Addendum No. 1

*Farmers Alliance Mutual Insurance
1122 North Main Street
McPherson, Kansas 67460*

Architect's Project Number: 22.31

Addendum No. 1 (Articles 1.1 thru 1.14) 2 Pages + Attachments

B3 WEST BREAK ROOM ELEVATION
SCALE: 1/2"=1'-0"

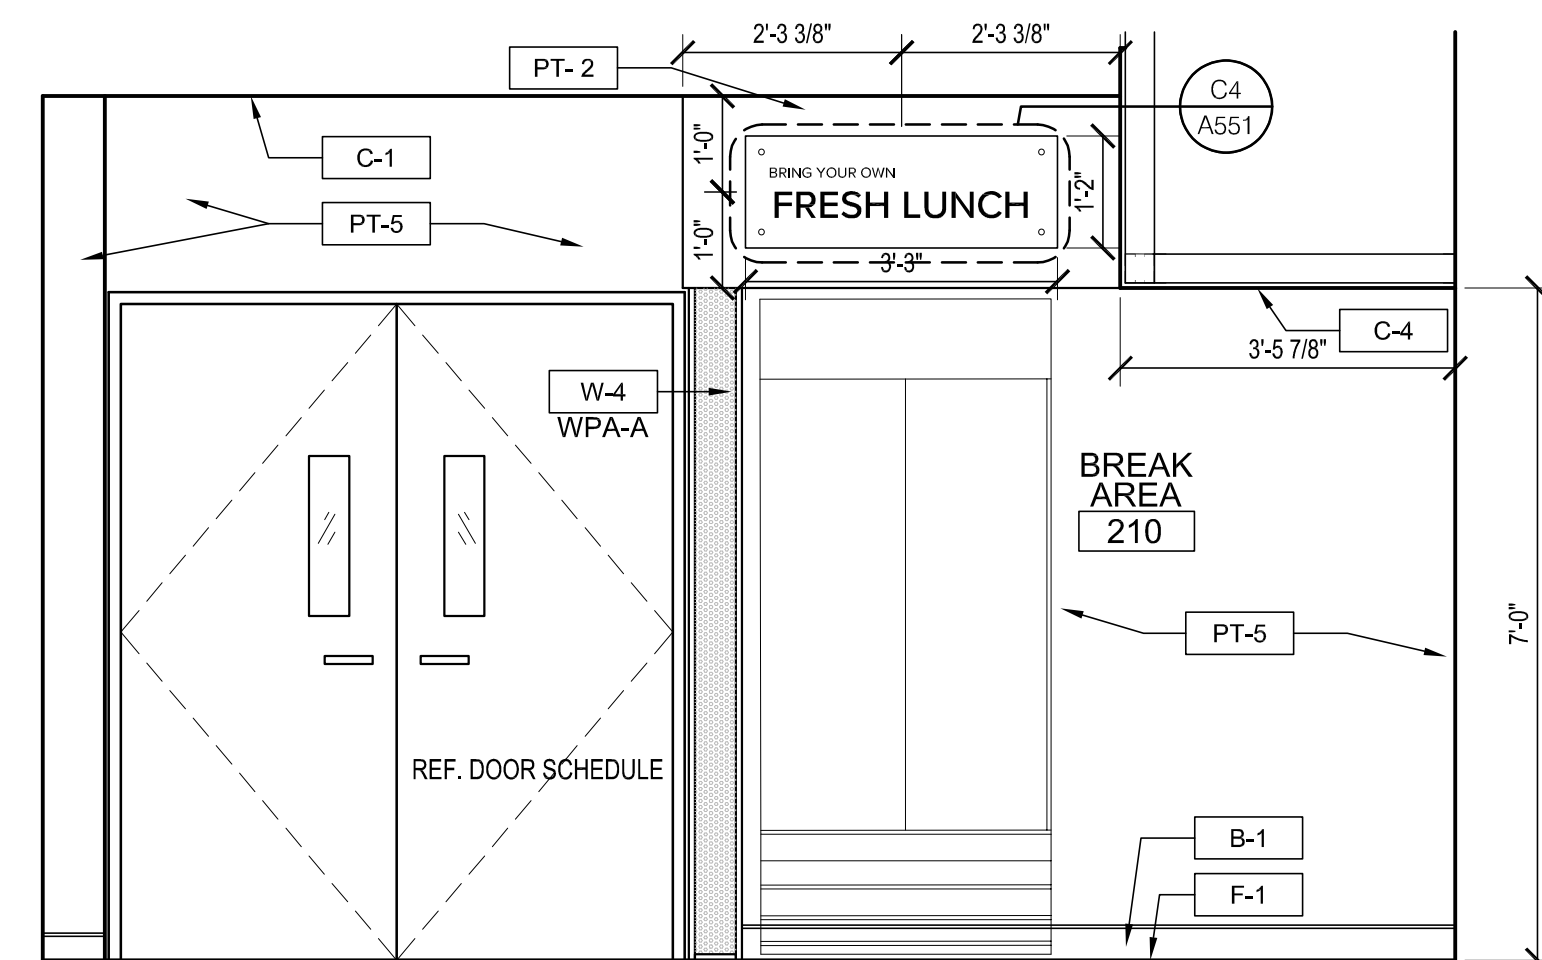
- A. **Revise:** Detail B3 West Break Room Elevation – Wall tile keynote from W-1 to W-2.

1. A010 Finish Schedule shows W2 on west wall of Break Room 209. Elevation B3 on A500 indicates W1. Can you indicate which is correct?

Response: Wall tile color is W-2.
